SP 2-219-002

SERVICE PROGRAM

Charge air cooler (CAC) pipe replacement.

This service program provides information regarding the replacement of the CAC pipe on certain 2016 model year Xpert vehicles equipped with ISB engines.

Figure 1

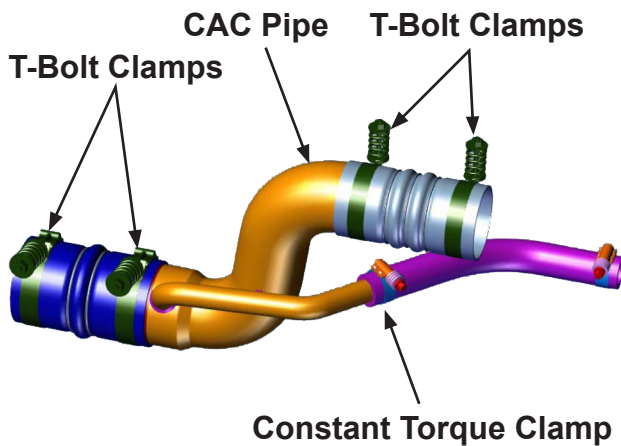
3. Remove and discard the CAC pipe by first loosening the T-Bolt clamps and then removing the constant torque clamp, and set aside for reinstallation (See Figure 1).

Figure 2

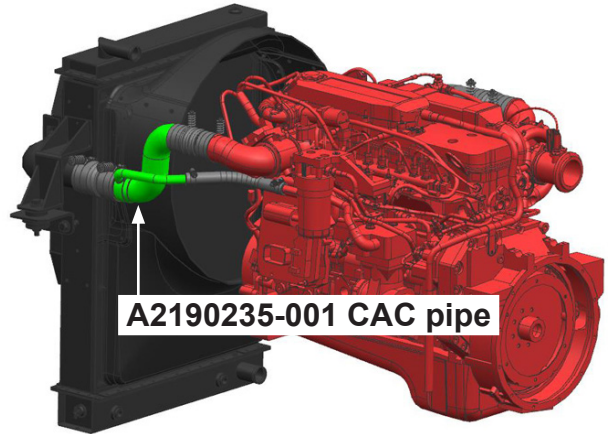
4. Install the new CAC pipe (A2190235-001) and tighten the T-Bolt clamps to 72 in.-lb of torque. Reinstall the constant torque clamp and tighten to 76 in.-lb of torque (See Figure 2).
